B0760x MAIN FIRMWARE RELEASE NOTES

WM-Nano Table Top Automatic Wrapper with PK-260B CPU Board

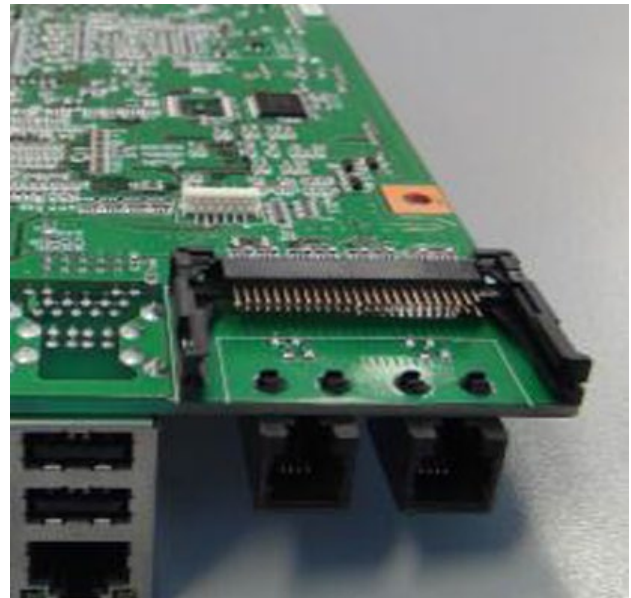
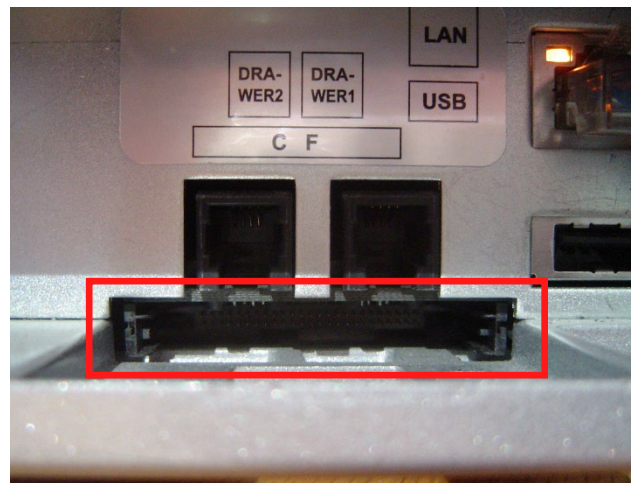
Firmware B0760x is designed for the revised CPU board PK-260B. **This firmware is not compatible with the previous CPU board PK-260A.** And previous firmware (B0684x, etc.) is not compatible with the new PK-260B CPU board.

The two CPU board versions can be easily identified by the expansion memory card slot located on the left side of the Uni-7 controller. See the images below.
